Re: Parallel Taxiway Construction  
Sturgis Municipal Airport  
Sturgis, South Dakota  
A.I.P. #3-46-0054-024-2025  
A-10027

**ADDENDUM NUMBER 2**

The following modifications are made to the plans and specifications for the Parallel Taxiway Construction Project at the Sturgis Municipal Airport.

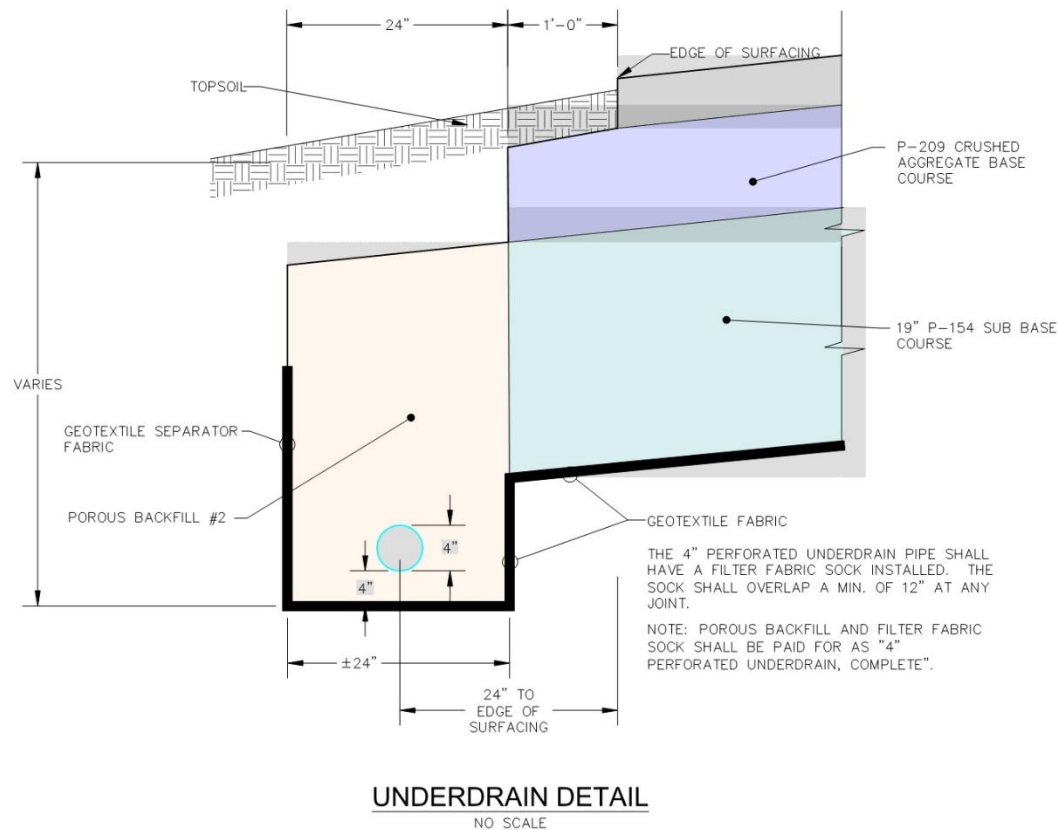
**3. Contract Documents, Special Conditions, SC-14 Special Provision for Disadvantaged Business Enterprise, Page 26, Definition Item C, delete in its entirety and replace with the following:**

- C. Disadvantaged Business Enterprise (DBE): A for-profit small business directory that is certified by the SDDOT and is listed in the DBE Directory available on the SDDOT's web site.

# ELECTRICAL VAULT PLAN

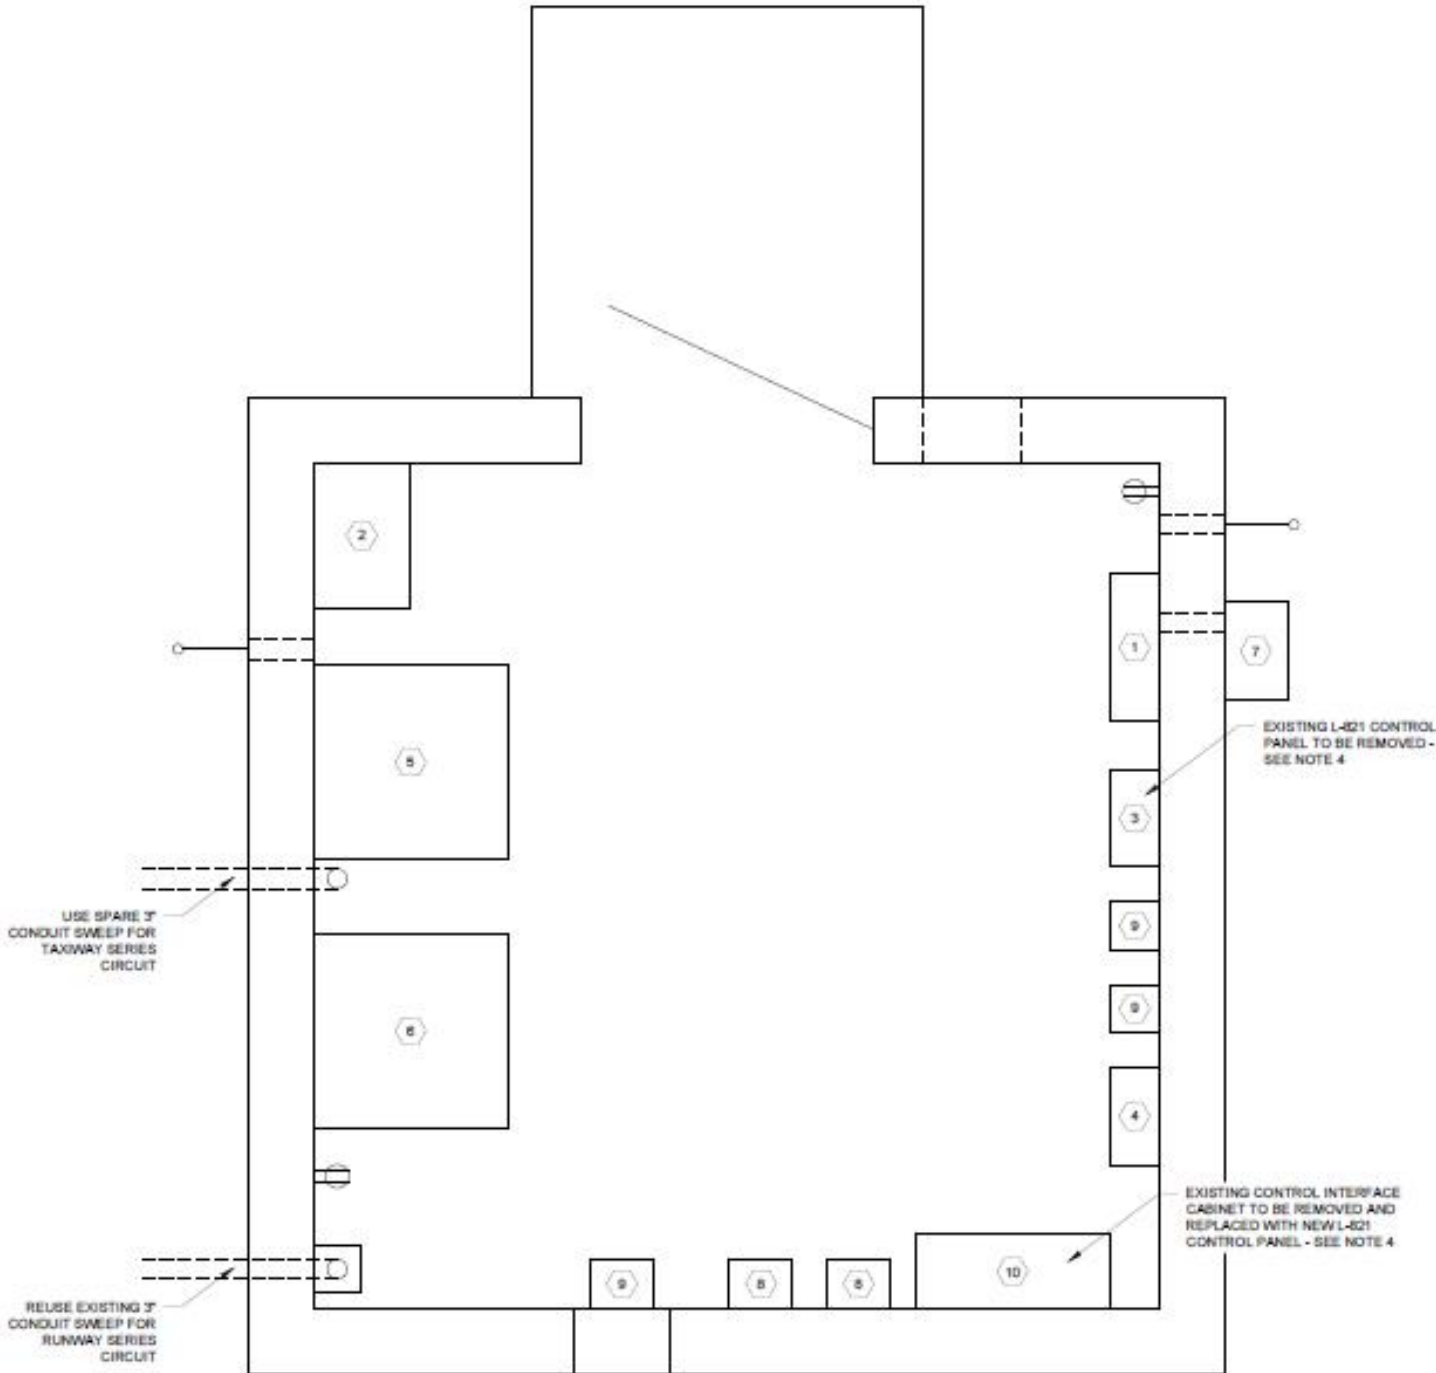
1. Electrical Technical Specifications, Item L-125 – Installation of Airport Lighting Systems, Pages 339-245 shall be deleted in its entirety and the attached specification shall be included in the contract documents and technical specifications.
2. Electrical Plans, Sheets 16 and 17, shall be deleted in its entirety and replace with the attached sheets.

No.	Revised	By	Date
1	ADDendum #2

GENERAL: DIMENSIONS OF EXISTING ELECTRIC ROOM ARE APPROX 9'-11" BY 5'-7"

- EXISTING 120 / 240V 200A MAIN PANEL TO BE REPLACED WITH NEW PANEL - REFER TO PANEL SCHEDULE
- EXISTING SUB PANEL "A1" 100 AMP
- EXISTING L-821 AIRFIELD LIGHTING CONTROL PANEL - TO BE REMOVED AND REPLACED
- EXISTING L-854 AIRFIELD CONTROL PANEL
- PROVIDE NEW FERRORESONANT TWY 7.5 KW CONSTANT CURRENT REGULATOR WITH INTERNAL S-1 CUTOUT
- PROVIDE NEW FERRORESONANT RWY 7.5 KW CONSTANT CURRENT REGULATOR WITH INTERNAL S-1 CUTOUT DISCONNECT AND SALVAGE 10 KW CCR
- ELECTRIC METER TO BE REPLACED WITH 320A METER SOCKET WITH BYPASS LEVER BY CONTRACTOR
- NEMA 1, HEAVY DUTY, DISCONNECT
- EXISTING NEMA 1, 5KVA, SINGLE PHASE 120 / 240-480V STEP-UP TRANSFORMER
- EXISTING CONTROL INTERFACE CABINET - TO BE REMOVED AND REPLACED
